ADA Curb Ramp New Construction Inspection Form (Perpendicular)

PERPENDICULAR RAMP (PR)

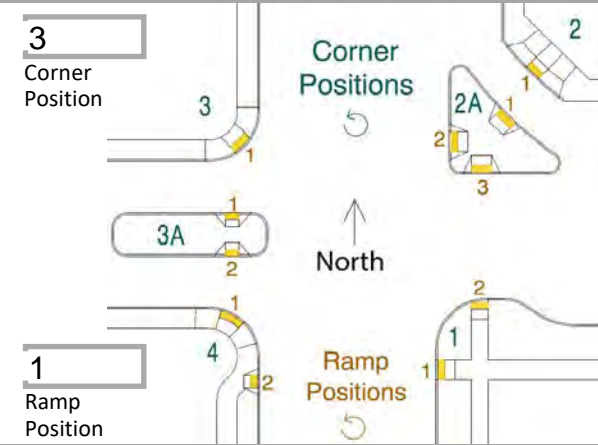
Counter Slope (+/-) *2

5.9

☒

CS FAIL NORTH END
